Sunrise Terrace

Sewer Basin Capacity Analysis

June 22, 2015 (REV)

APPENDIX 2: City of La Center comments and Responses.

Figure 3 - Sub-Basin Schematic

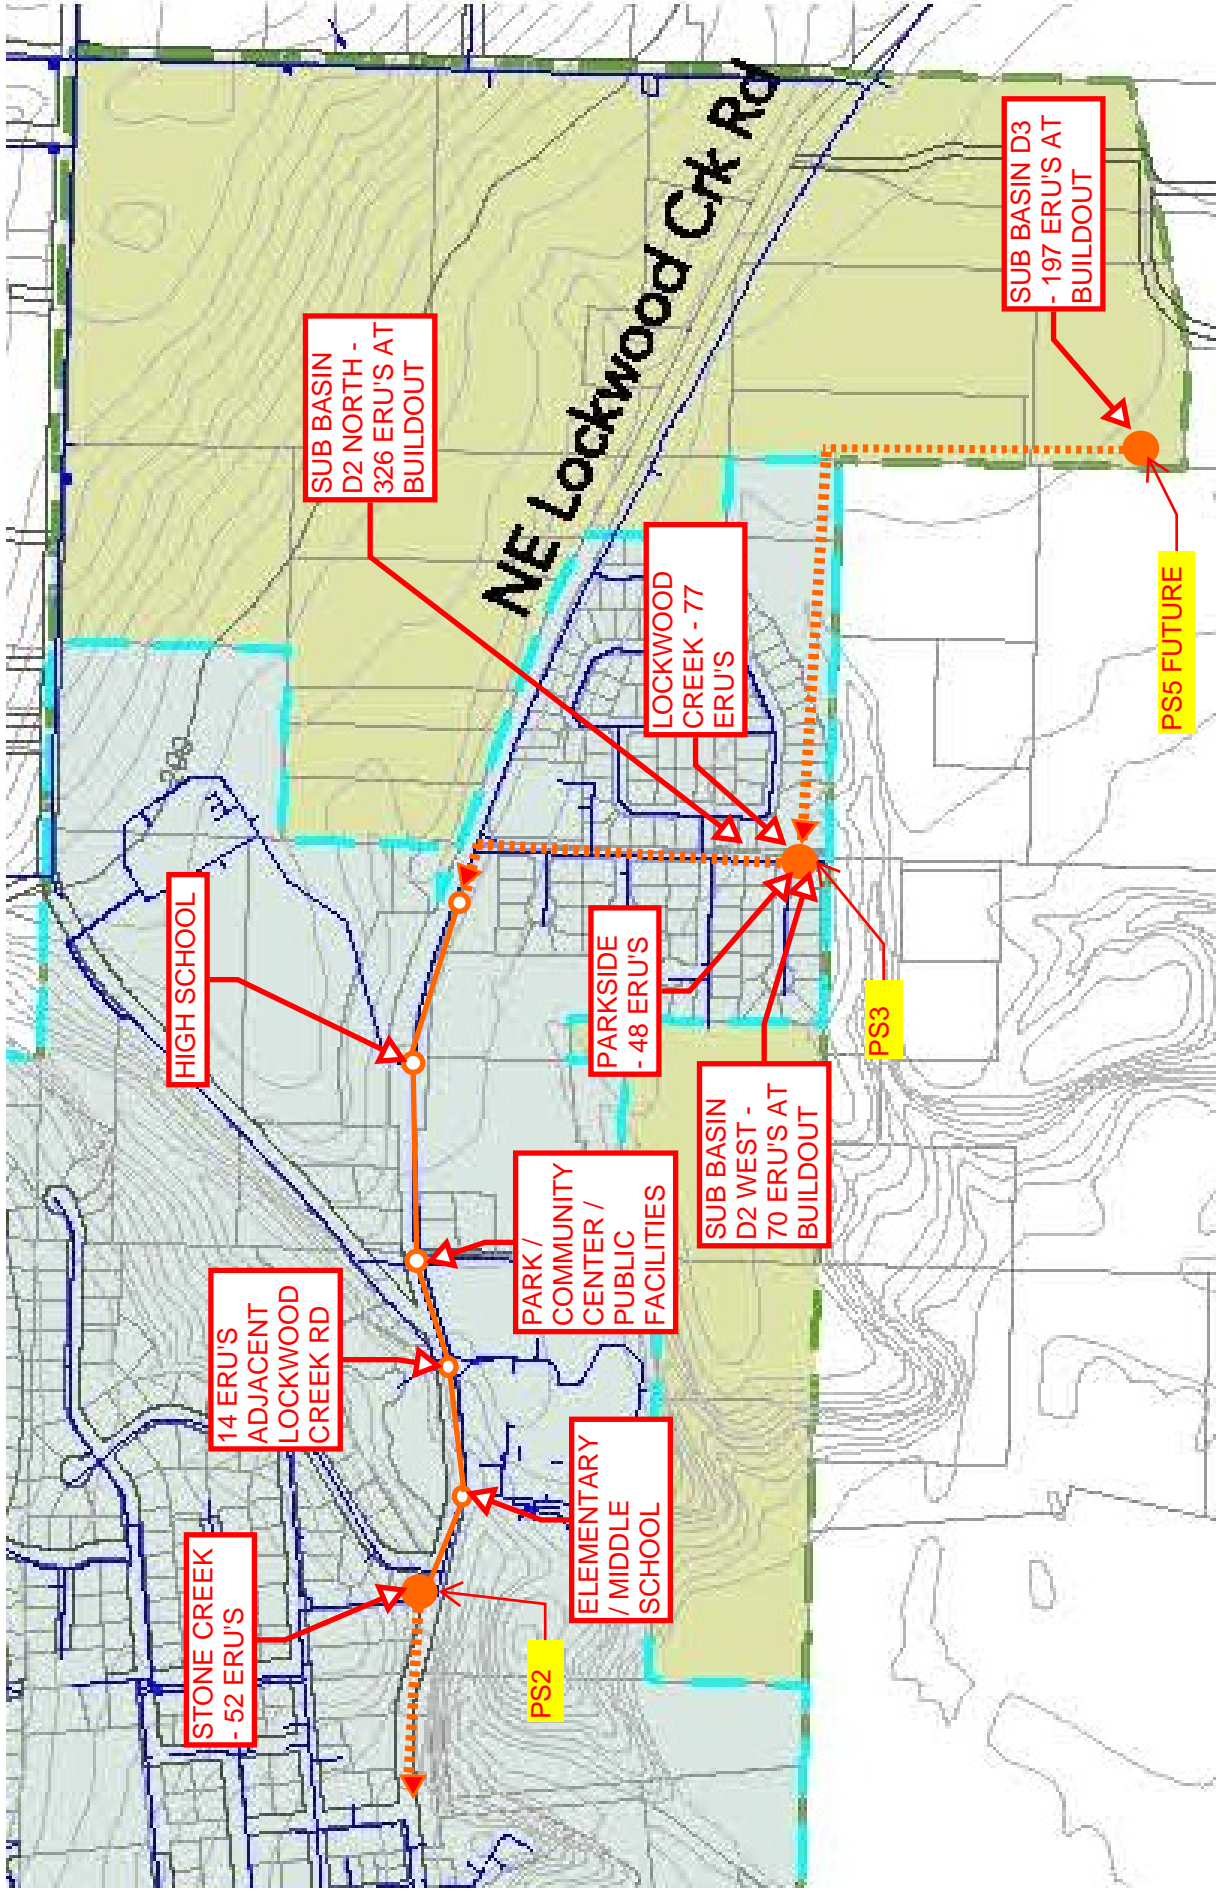
1. Wallis Engineering notes that it is not clear that calculated capacities include pump station 5 discharging into pump station 3 and then to pump station 2. Submit a diagram or figure showing the anticipated build out flow to help resolve the flow path.

RESPONSE:

See Figure 3 – Sub Basin Schematic, attached.

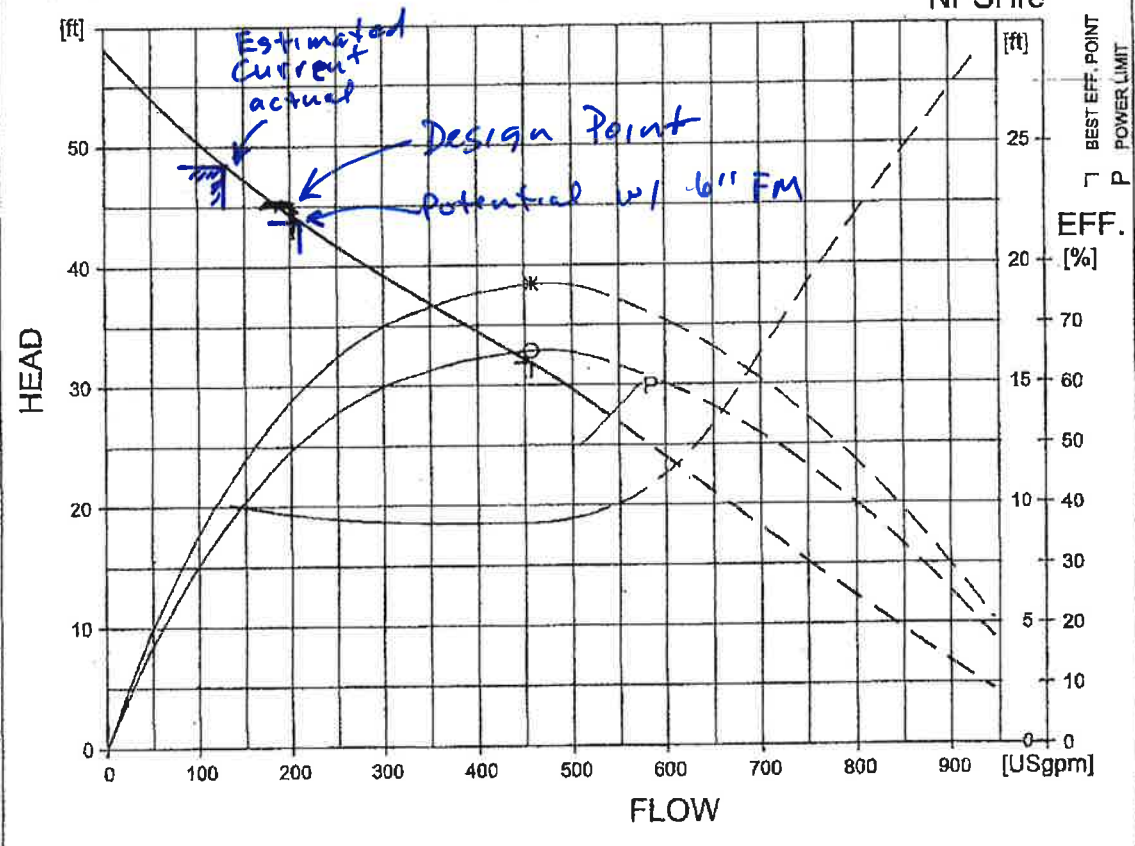
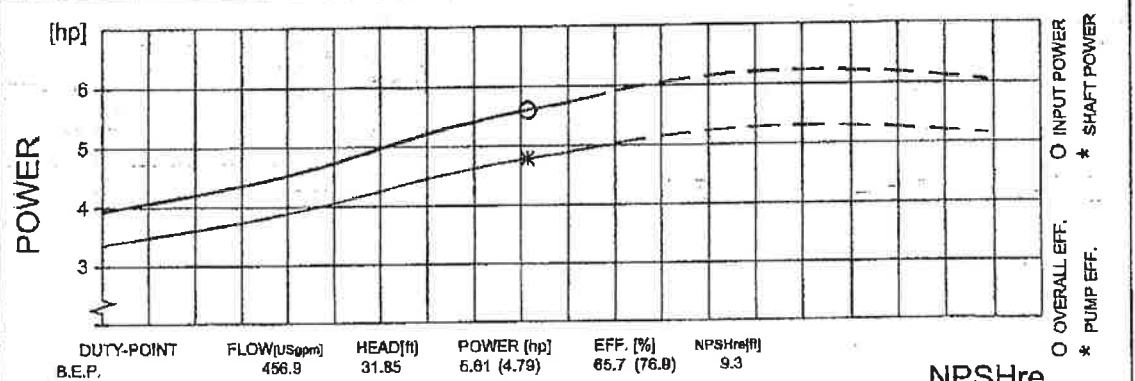
Pump station #2 has had some modifications including a new impeller and it will likely work efficiently in the near future. The City has conducted some preliminary hydraulic analysis of pump station #2 with the existing 4-inch force main and found that by increasing the existing force main from a 4-inch diameter to a 6-inch diameter pipe, this will likely give enough capacity to operate up to 200 gallons per minute. The engineer will need to submit supporting calculations to support this change in pipe size.

- a. *Wallis Engineering comments that discussing these elements in the report is beneficial to identifying potential capacity upgrades. These modifications should be discussed in the report.*

Pump station No. 2 shows a design point of 200 gpm at 45 ft of head. The actual pumping rate was calculated at 130 gpm. This rate would indicate a design point on the curve of 48 ft of pumping head. At 130 gpm, the head loss in 600 feet of 4 inch force main is about 8 feet with fittings and therefore the pumps are seeing 40 feet of elevation head. Replacement with a 6 inch force main would result in about 4 feet of friction loss and potentially would result in a design point for the existing pumps of 210 gpm at 44 feet of head. Since the force main will ultimately need to be upgraded to a 6 inch. Upgrading the force main could create additional capacity without changing out the pumps and panel. The Flygt NP3102 pump curve is attached with the indicated points.

CURVE: RC-5834

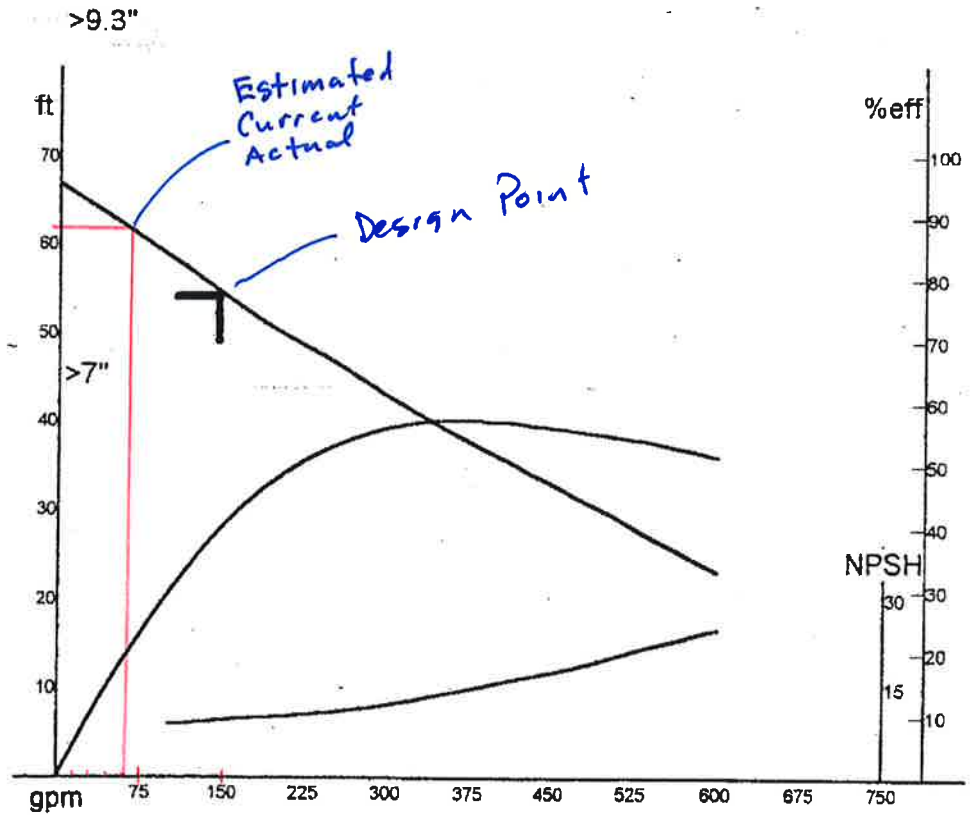
3. Wallis Engineering comments that the City has identified that pump stations #2 and #3 currently operate at capacity. The possibility of the City increasing capacity and efficiency of the existing pump stations was discussed in meeting. Since the meeting, operation adjustments were discussed and reviewed by the City. We believe that pump station #3 cannot be modified to provide additional capacity of the system.

Pump station No. 3 shows a design point of 144 gpm at 55 ft of head. Current performance would indicate an operating condition of 58 gpm at 62 ft. of head based on the calculated rate. Information from the General Sewer Plan sets the discharge manhole invert at elevation 145. The as built for station 3 shows a pumping elevation of about 83. If the elevation information is on the same datum, this would represent a pumping head of 62 feet before friction is considered. It would appear that the pumps in station 3 may be performing to specifications. All information and assumptions will need to be field verified. The solution to the capacity of Pump station No. 3 will be to reassess the elevation and friction and select pumps for the required condition. This may require upsizing of pumps and panel. The PACO curve RC-5834 with the design and estimated actual performance points is attached.
